**Amendments to the Drawings:**

Response to Final Office Action  
Application Serial No. 10/077,086  
Annotated Sheet Showing Changes

FIG. 1

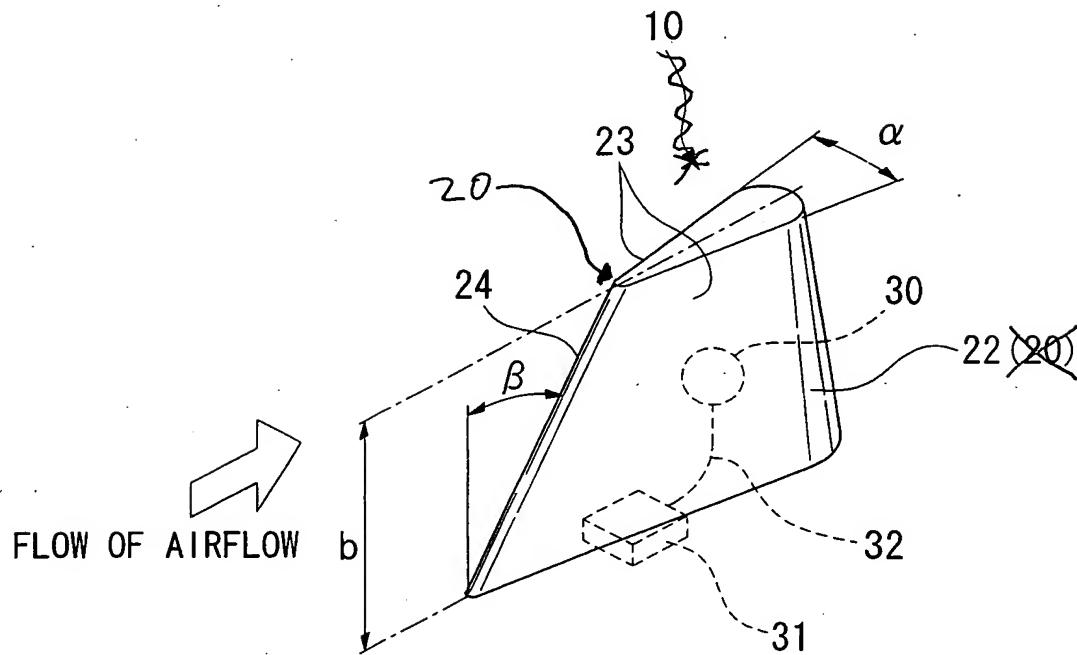
Fig. 1 has been amended to more clearly identify single wedge shaped casing 20, as well as to more clearly show that temperature sensor 10 includes all of the elements shown in Fig. 1.

Figs. 1 and 2 have been amended as described hereinabove to more clearly identify the single wedge shaped casing 20, in accordance with the description in the specification at page 6, lines 1-8.
